**To:** Public Inquiry Inspector  
**Subject:** Proof of Evidence for Application for the Proposed Network Rail (Cambridge South Infrastructure Enhancements) Order  
**Objector:** OBJ/22  
**Date:** 7 January 2022  
**Author:** Edward Leigh MA MSc  
 42 Devonshire Rd, Cambridge, CB1 2BL  
 01223 312 377 / [edward@smartertransport.uk](mailto:edward@smartertransport.uk)

## About Smarter Cambridge Transport

Figure 1: MSOA zone Cambridge 013

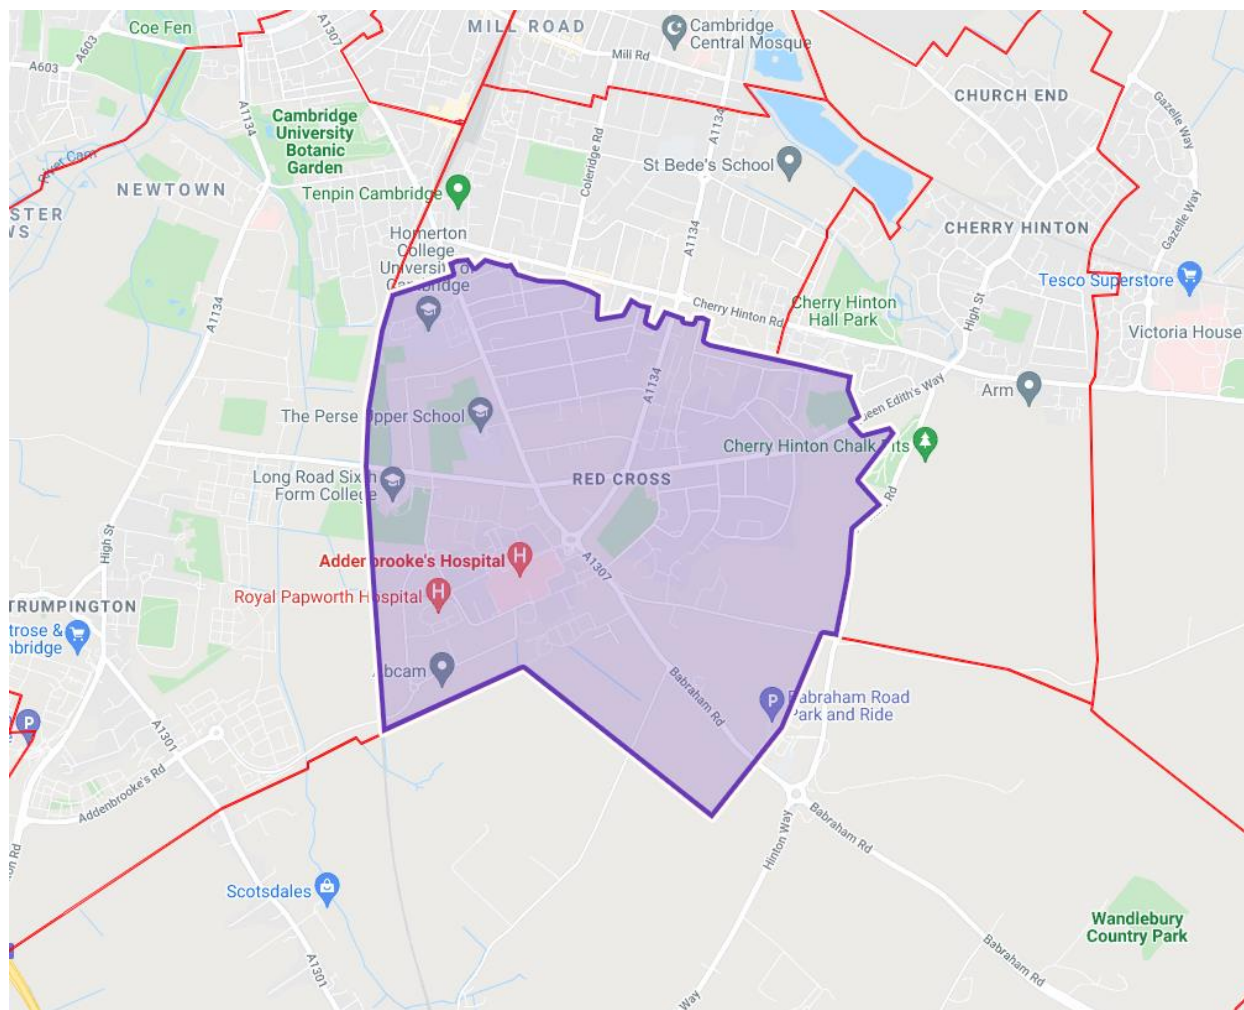
O39. The TEMPro figure for jobs in MSOA Cambridge 013 (see Figure 1) grows by 289 from 2019 to 2022, not by 700 as reported.

O40. The TEMPro figure for jobs in MSOA Cambridge 013 (see Figure 1) grows by 468 from 2021 to 2031, not by 860 as reported.

Figure 3: Proposed design for station access junction with Francis Crick Avenue (from NR13 Deemed Planning Drawings)

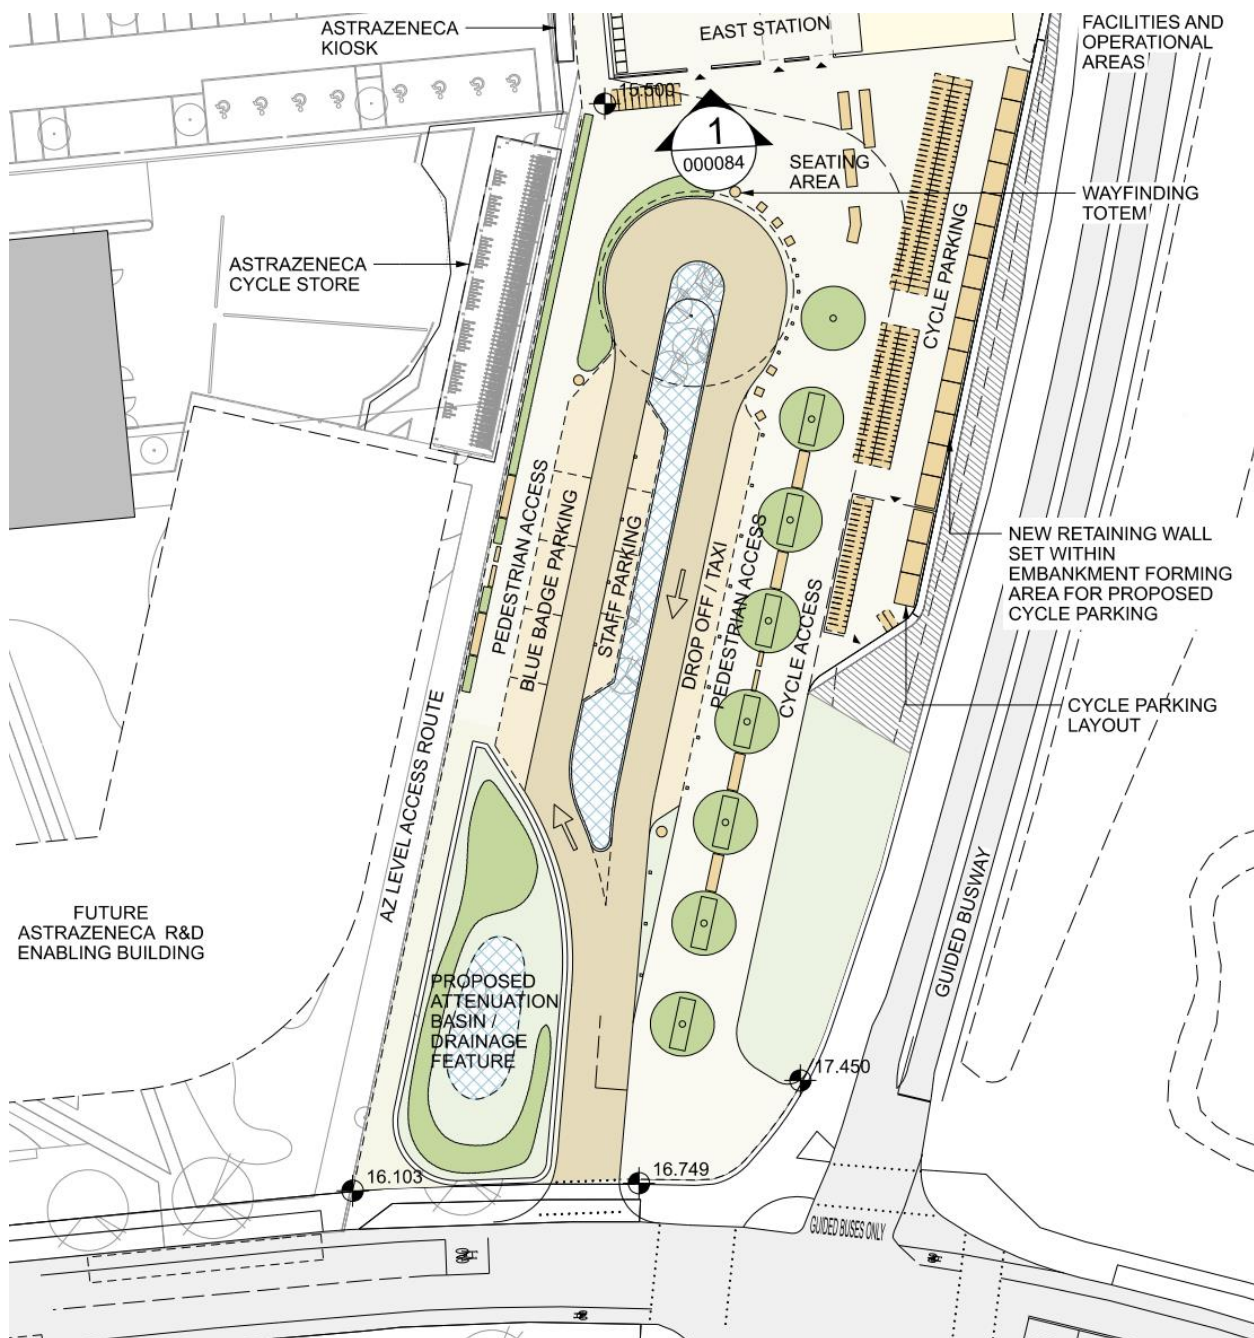
O34. Any underestimation in demand or significant deviations in demand from the average will lead to congestion on the access road (see Figure 3), potentially causing blocking back onto Francis Crick Avenue. It is unclear whether this has been modelled.

**Q18. What modelling has the applicant conducted of vehicular movements in and out of the station access road?**

Figure 4: Diagram of busway junction with Francis Crick Avenue (from CSET plan dated 12 Feb 2021)

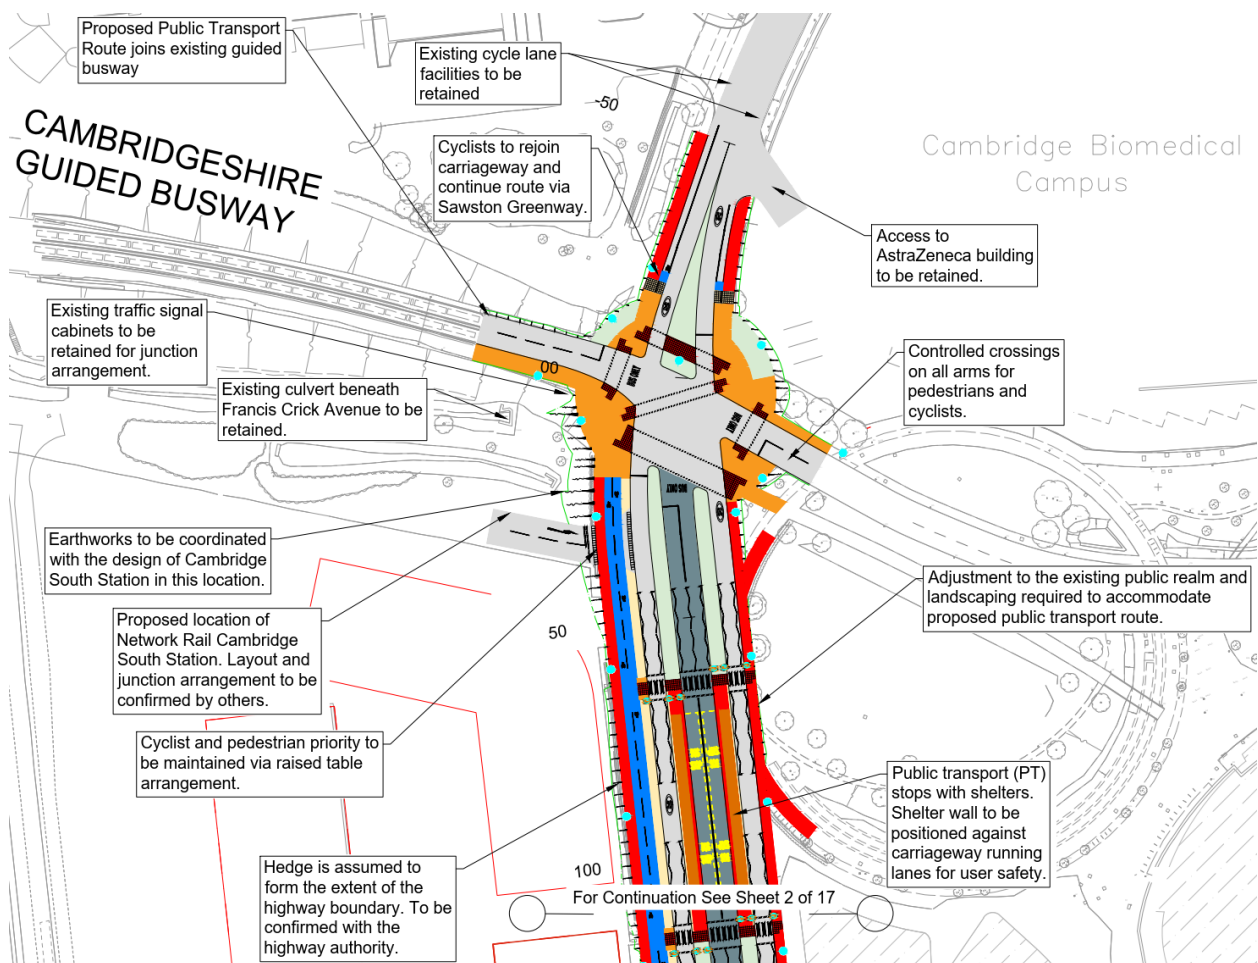
10. The access arrangement at Francis Crick Avenue is highly conflicted. Potentially large crowds of people arriving and leaving by foot and cycle will have to negotiate a complex crossing of Francis Crick Avenue, which is planned to comprise two general traffic lanes, two bus lanes and two cycle lanes (see Figure 4).

O36. The bus stops on Francis Crick Avenue (see Figure 4) will be 200m from the station entrance. If alighting from the rearmost carriage of a 12-car train, the walk will be 450m (see Figure 5), taking 7 minutes at a typical walking pace of 4km/hour, not including time spent waiting for space on the stairs or lifts.

Figure 6: Schematic representation of alternative station configuration and access arrangements

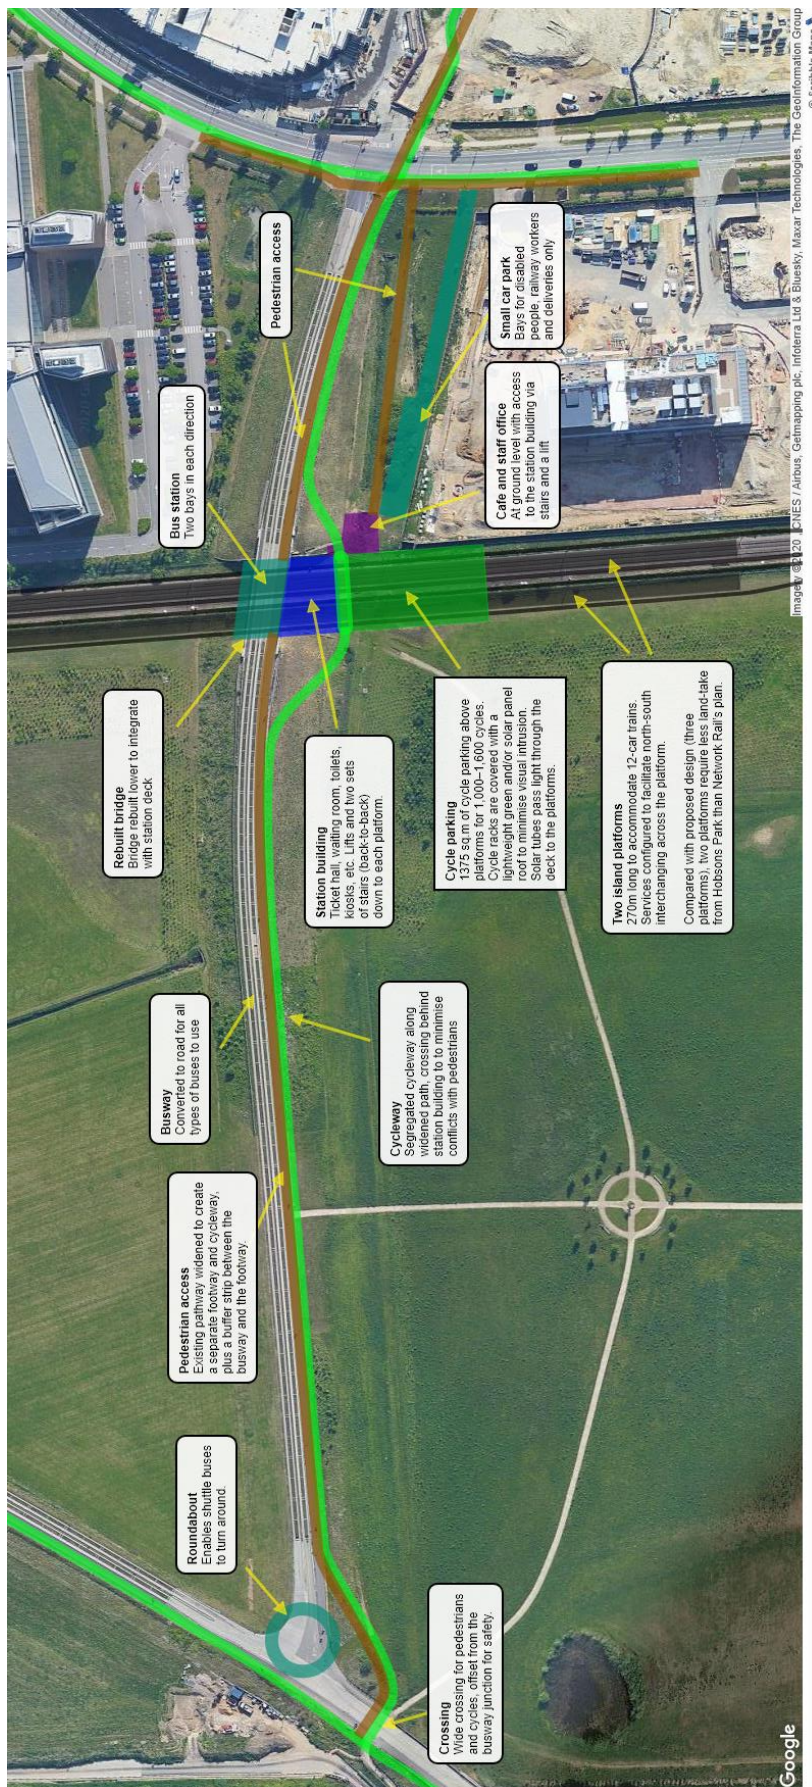
4. Any increase in rail usage will strengthen the business case for Cambridge South station. That in turn will justify the design, construction and operation of a larger station along the lines we have proposed (see Figure 6). This would see the station ticket hall and cycle parking located above the tracks. The main entrance would be from the rebuilt busway bridge, which would be widened to include a bus station immediately opposite the station entrance. There would be very limited vehicular access for private vehicles, so as to minimise conflicts and congestion on and around Francis Crick Avenue.

O67. We recommend (see Figure 6):

- As part of rebuilding the bridge, widen the non-motorised user path, segregate it for pedestrians and cycles, and separate it from the busway by a buffer strip.
- Locate the cycle park behind (south of) the ticket hall with its own entrance to the station, and connected directly to the cycleway on each side of the bridge.
- Provide parking bays at ground level only for disabled people, railway workers and deliveries.
- Do not provide a taxi rank or private pick-up/drop-off area. Limit vehicular access to disabled users and railway workers. All train services that stop at Cambridge South also stop at Cambridge station, which will continue to be accessible by taxi and private cars. Therefore, there is no need for provision for car pick-up or drop-off at Cambridge South station.

Figure 7: Diversionary route for cycles and pedestrians while the busway bridge is closed. Buses would travel via the Addenbrooke's Rd–Hobson Ave roundabout.

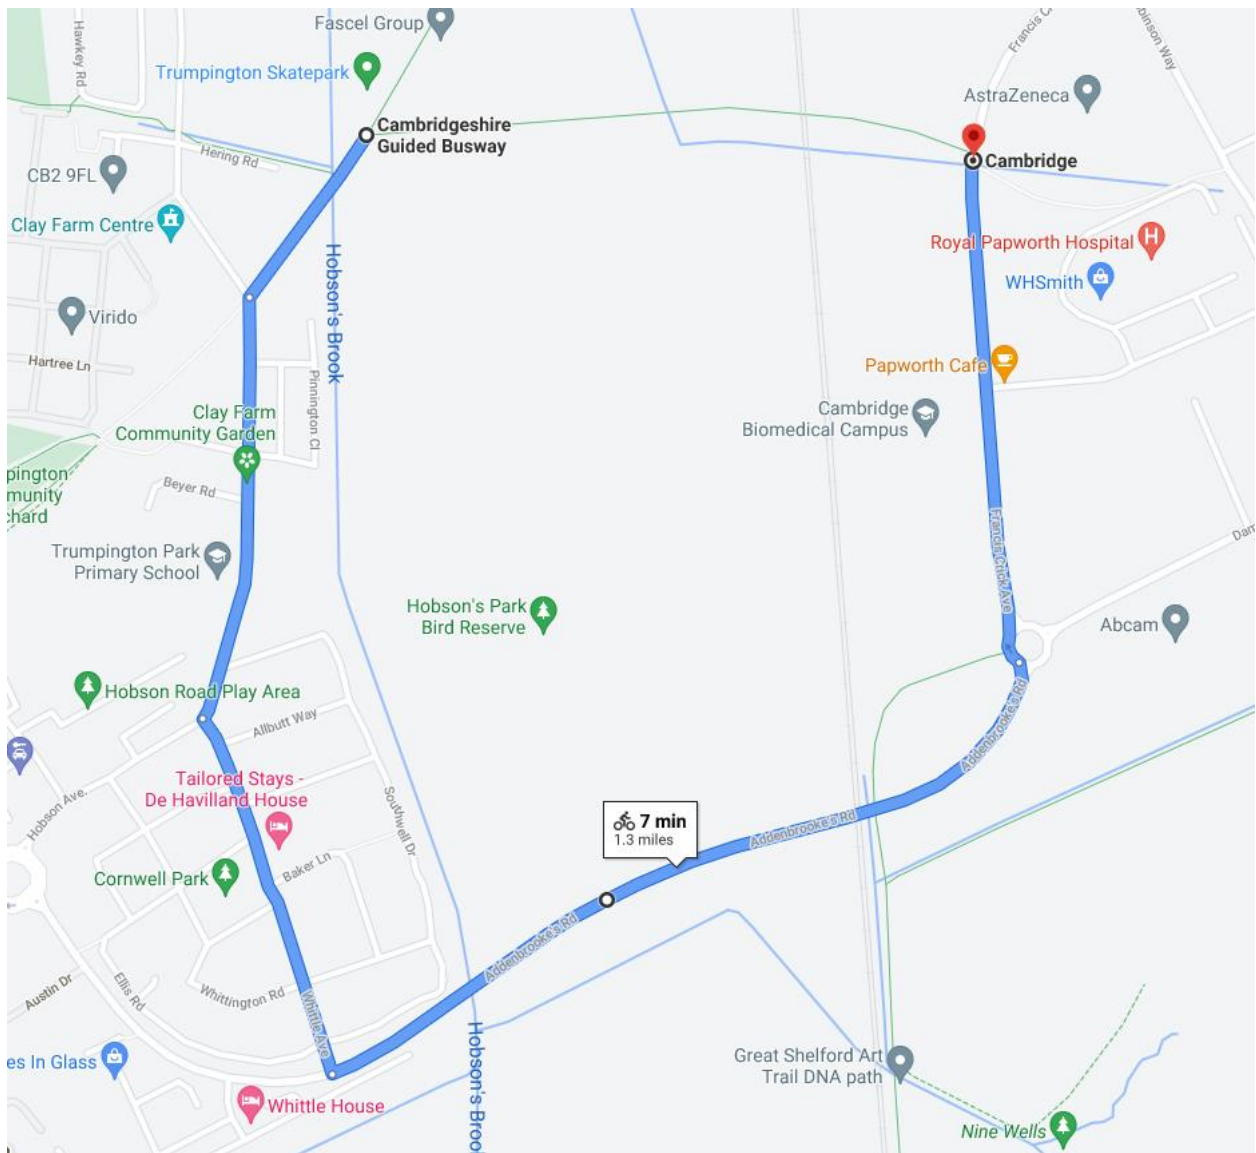
O66. Disruption during construction would be unavoidable, but a temporary bus and cycle diversion via Addenbrooke’s Rd and Hobson Ave and, for cycles and pedestrians, Whittle Ave (see Figure 7), would be feasible and not overly burdensome for a few weeks. The supposed complexity of maintenance and safety issues are not explained, and can almost certainly be overcome with an appropriate design and budget. Any concerns about the visual impact may be addressed through the use of sympathetic architecture and landscaping.
